Kansas Department of Agriculture
 Division of Water Resources
CHANGE: P/D WORKSHEET

RE: Water Right, File No. 3941

DWR FIELD OFFICE APPLICATION FOR APPROVAL TO CHANGE THE PLACE OF USE AND/OR THE POINT OF DIVERSION

RE: Application for Change in Point of Diversion
Water Right, File No. 3941

Change in point of diversion application for water right 3941

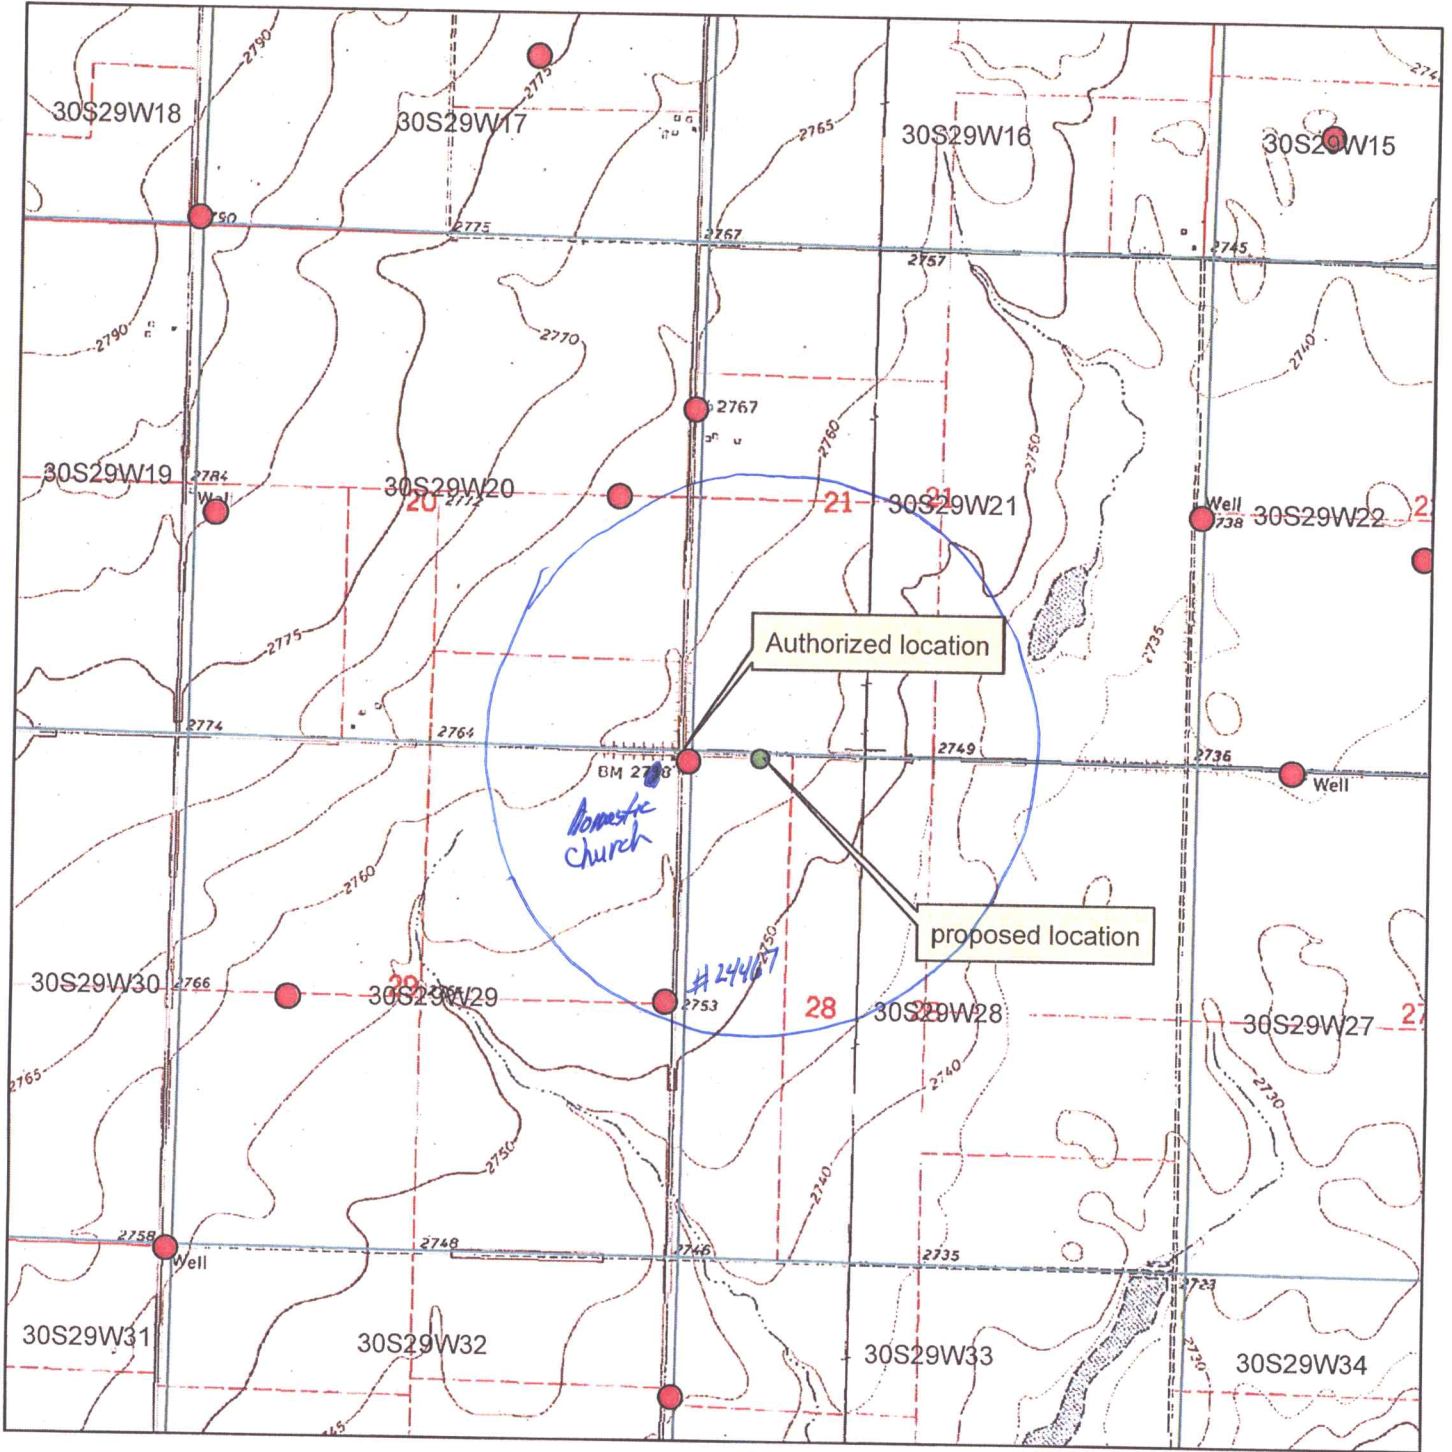
We have completed a review of the application for the above referenced water right. The proposed change in point of diversion is in accordance with current area rules, K.A.R. 5-23-3, as it pertains to distance moved and minimum spacing to neighboring wells.

Every neighboring well within 1 mile of the proposed move was evaluated. Evaluations showed that none of the neighboring wells exceeded the net effect above the maximum allowable threshold. Our office received no comments of concern from neighboring well owners. Therefore, GMD3 sees this move as reasonable and therefore recommend that the application be approved. If aquifer conditions change or there is a change to the water right in the future, we would be happy to evaluate the effects at that time.

Recommendation: After review of all available information, current area rules are met. The proposed move is well within our guidelines. Staff therefore recommends approval of the application.

WELL TEST ANALYSIS

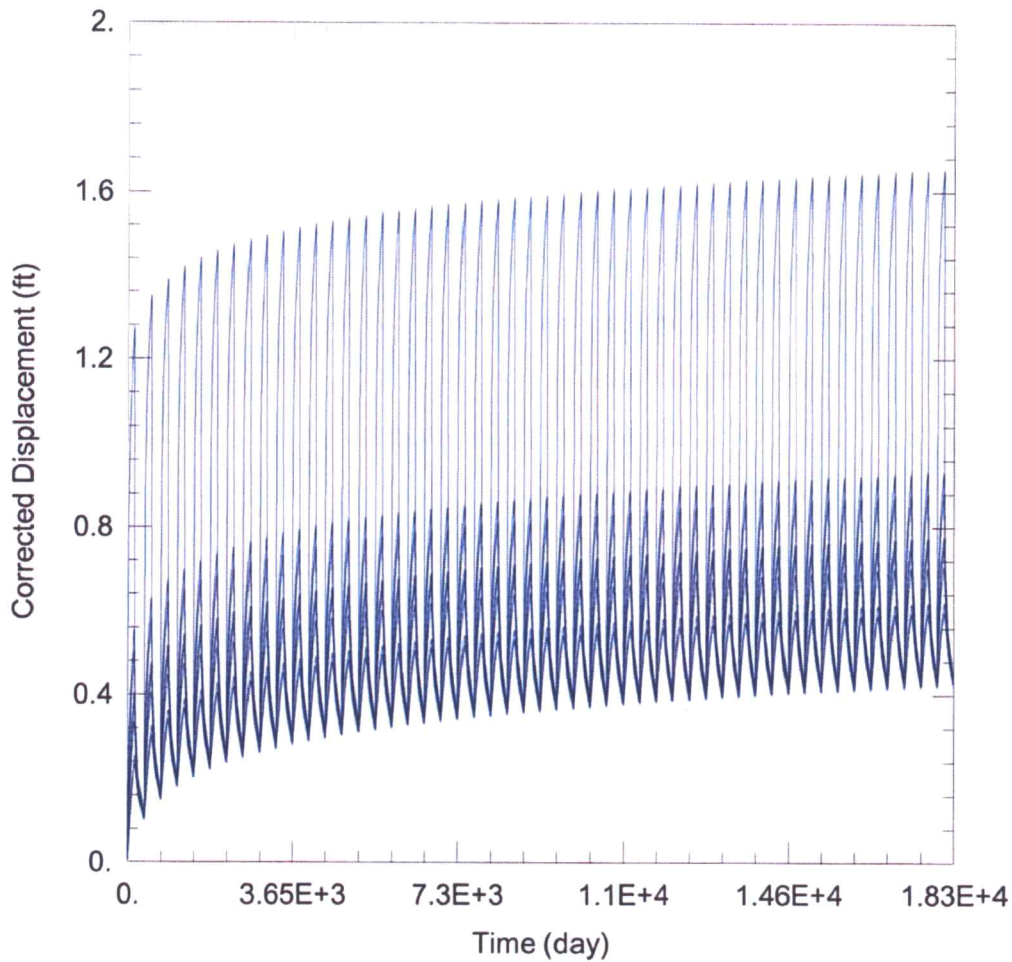
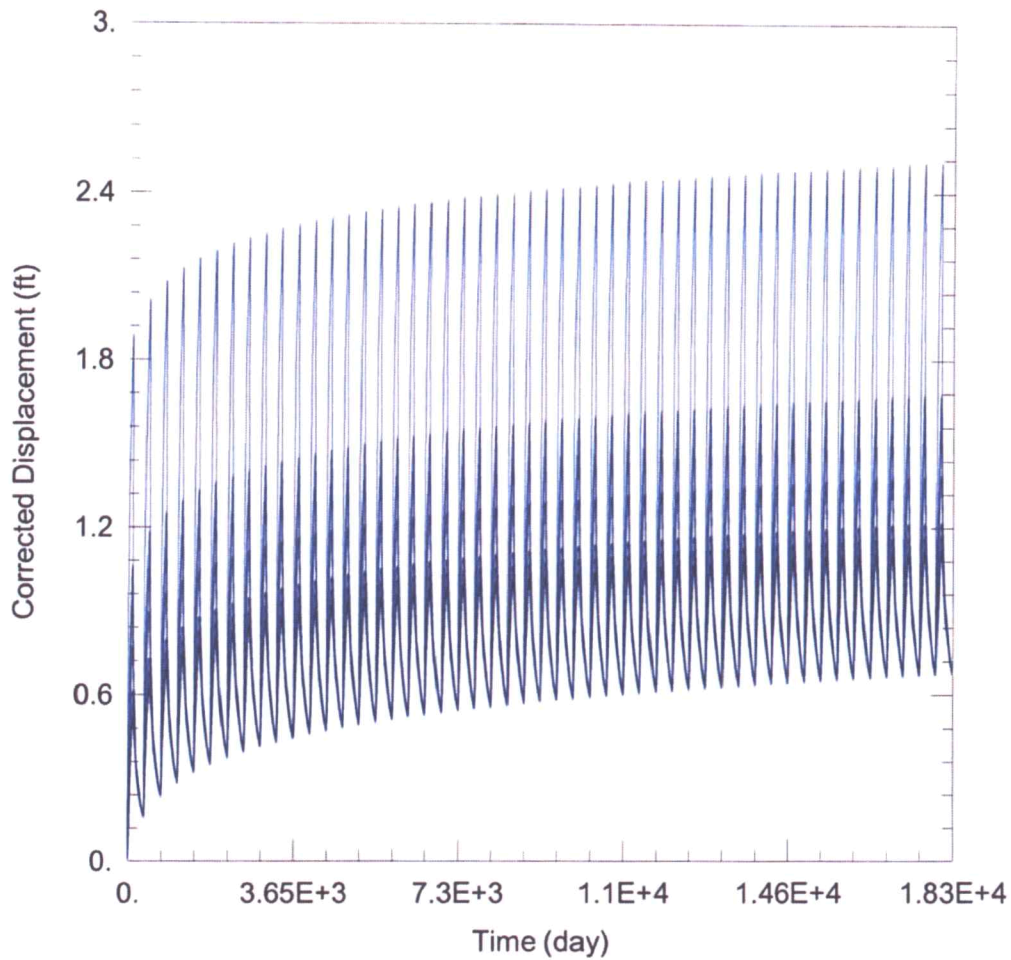
7544: Drawdown from current location = 0.60 ft
Drawdown from proposed location = 1.11 ft
Net drawdown = **0.5 ft**

24467: Drawdown from current location = 0.93 ft
Drawdown from proposed location = 1.68 ft
Net drawdown = **0.7 ft**

Domestic 1: Drawdown from current location = 0.70 ft
Drawdown from proposed location = 1.12 ft
Net drawdown = **0.4 ft**

Domestic 2: Drawdown from current location = 0.75 ft
Drawdown from proposed location = 1.22 ft
Net drawdown = **0.5 ft**

Domestic 3: Drawdown from current location = 0.62 ft
Drawdown from proposed location = 1.17 ft
Net drawdown = **0.5 ft**

Domestic 4: Drawdown from current location = 1.65 ft
Drawdown from proposed location = 2.51 ft
Net drawdown = **0.9 ft**

Net drawdown does not exceed the drawdown allowance of 4.0 ft for any well within 1 mile of the proposed location. Therefore, critical well analysis is not necessary.

The proposed move is likely to create minimal effects on neighboring wells and is unlikely to cause impairment. GMD3 staff recommends approval of this proposal.
